SUBJECT: REQUEST FOR ADDITIONAL INFORMATION ON QUAD CITIES IPEEE  
SUBMITTAL (TAC NOS. M83665 AND M83666)

Quad Cities Nuclear Power Station  
Unit Nos. 1 and 2

**QUAD CITIES**  
**Request for Additional Information**

Figure A.1 Sensitivity of the hot gas layer temperature predictions to the assumed heat loss factor

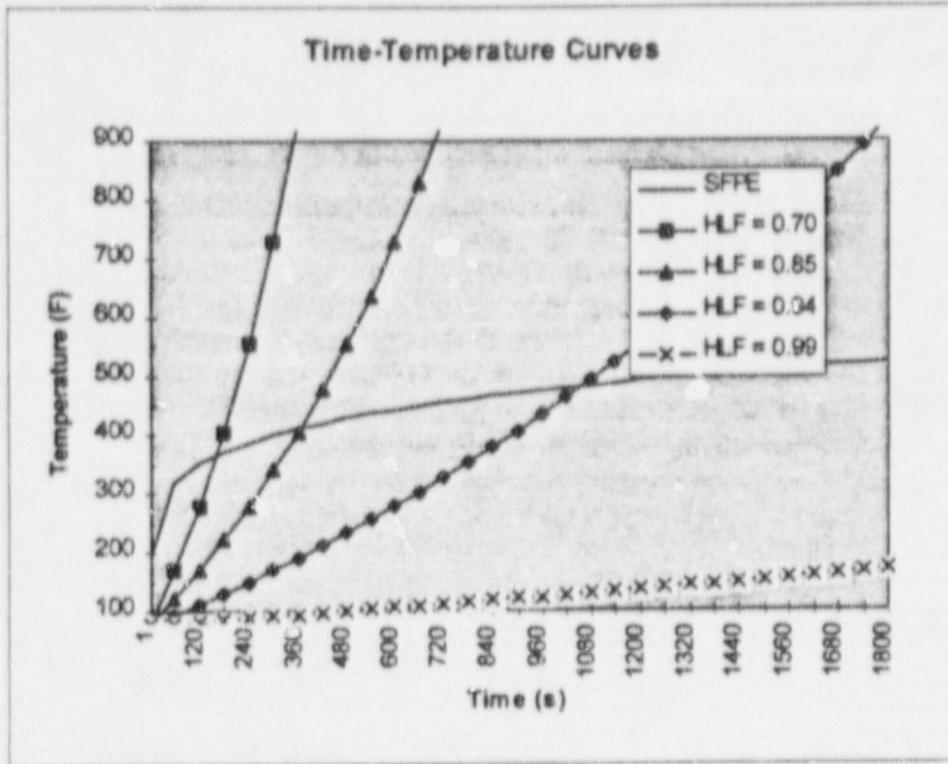
3. The heat loss factor is defined as the fraction of energy released by a fire that is transferred to the enclosure boundaries. This is a key parameter in the prediction of component damage, as it determines the amount of heat available to the hot gas layer. In the Fire-Induced Vulnerability Evaluation (FIVE), the heat loss factor is modeled as being inversely related to the amount of heat required to cause a given temperature rise. Thus, for example, a larger heat loss factor means that a larger amount of heat (due to a more severe fire, a longer burning time, or both) is needed to cause a given temperature rise. It can be seen that if the value assumed for the heat loss factor is unrealistically high, fire scenarios can be improperly screened out. Figure A.1 provides a representative example of how hot gas layer temperature predictions can change assuming different heat loss factors. Note that (1) the curves are computed for a 1000-kW fire in a 10m x 5m x 4m compartment with a forced ventilation rate of 1130 cfm, (2) the FIVE-recommended damage temperature for qualified cable is 700 degrees Fahrenheit for qualified cable and 450 degrees Fahrenheit for unqualified cable, and (3) the SFPE curve in the figure is generated from a correlation provided in the Society for Fire Protection Engineers Handbook [1].

Based on evidence provided by a 1982 paper by Cooper et al. [2], the *EPRI [Electric Power Research Institute] Fire PRA Implementation Guide* recommends a heat loss factor of 0.94 for fires with durations greater than 5 minutes and 0.85 for "exposure fires away from a wall and quickly developing hot gas layers." However, as a general statement, this appears to be a misinterpretation of the results. Reference [2], which documents the results of multi-compartment fire experiments, states that the higher heat loss factors are associated with the movement of the hot gas layer from the burning compartment to adjacent, cooler compartments. Earlier in the experiments, where the hot gas layer is limited to the burning compartment, Reference [2] reports much lower heat loss factors (on the order of 0.51 to 0.74). These lower heat loss factors are more appropriate when analyzing a single compartment fire. In summary, (a) hot gas layer predictions are very sensitive to the assumed value of the heat loss factor; and (b) large heat loss factors cannot be justified for single-room scenarios based on the information referenced in the *EPRI Fire PRA Implementation Guide*.

*For each scenario where the hot gas layer temperature was calculated, please specify the heat loss factor value used in the analysis. In light of the preceding discussion, please either: a) justify the value used and discuss its effect on the identification of fire vulnerabilities, or b) repeat the analysis using a more justifiable value and provide the resulting change in scenario contribution to core damage frequency.*
